dsPIC33FJ06GS101/X02 and dsPIC33FJ16GSX02/X04

dsPIC33FJ06GS101/X02 and dsPIC33FJ16GSX02/X04 Family Silicon Errata and Data Sheet Clarification

The dsPIC33FJ06GS101/X02 and dsPIC33FJ16GSX02/X04 family devices that you have received conform functionally to the current Device Data Sheet (DS70000318G), except for the anomalies described in this document.

FIGURE 1: TIMING DIAGRAMS FOR CENTER-ALIGNED AND EDGE-ALIGNED MODES

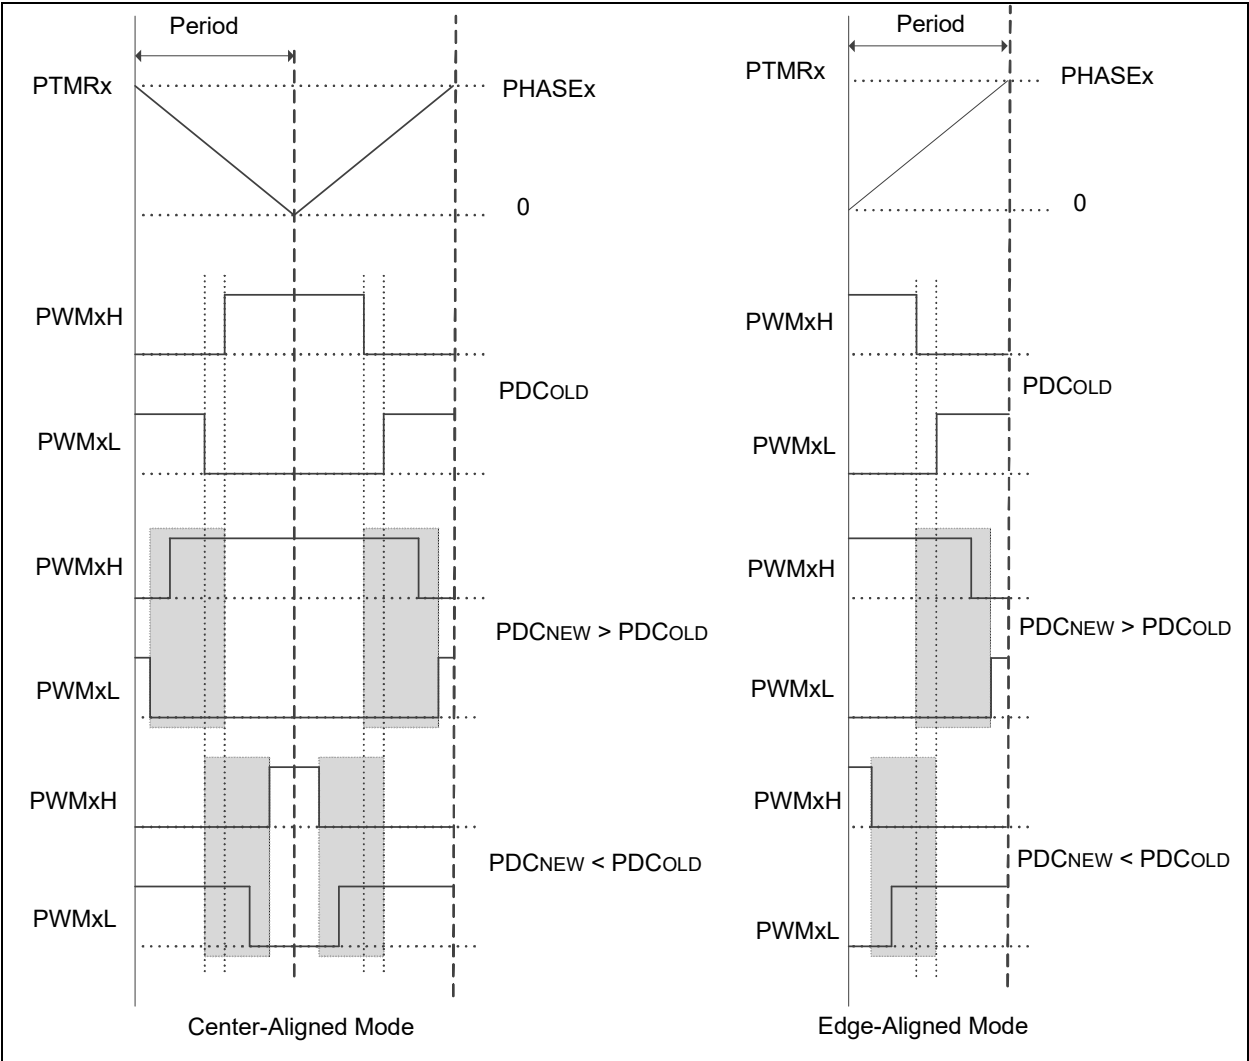
In [Figure 1](#) (following page), if the duty cycle write occurred in the shaded box, then PWMxH and PWMxL will make an immediate transition without dead time.

FIGURE 2: ISSUE EXAMPLE FOR REDUNDANT OUTPUT MODE

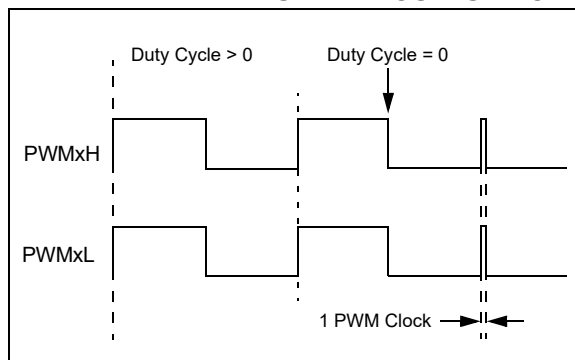
In Redundant Output mode (IOCONx[11:10] = 01) and Push-Pull Output mode (IOCONx[11:10] = 10), with the Immediate Update disabled (PWMCONx[0] = 0), when the Duty Cycle register is updated from a non-zero value to zero, a glitch pulse of a width equal to one PWM clock will appear at the next PWM period boundary, as shown in Figure 2 (for the Redundant Output mode). The Duty Cycle register refers to the PDCx register if PWMCONx[8] = 0 or the MDCx register if PWMCONx[8] = 1.

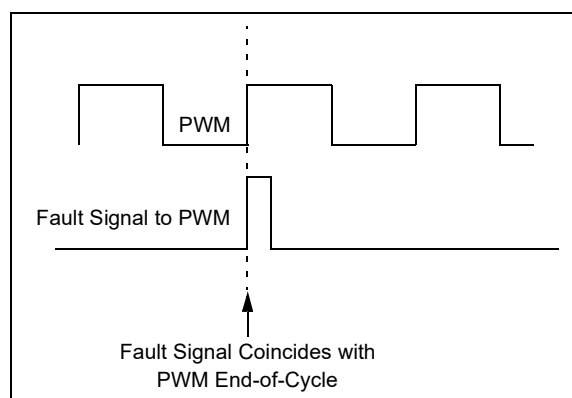
When the PWM module is operated in Complementary, Redundant, Push-Pull or True Independent Output modes and the PWM Fault/Current-Limit Fault are configured to provide a Fault event to the PWM, under certain conditions where the Fault event active edge happens to coincide with the PWM End-of-Cycle (EOC) event, the PWM fails to recognize the Fault event.
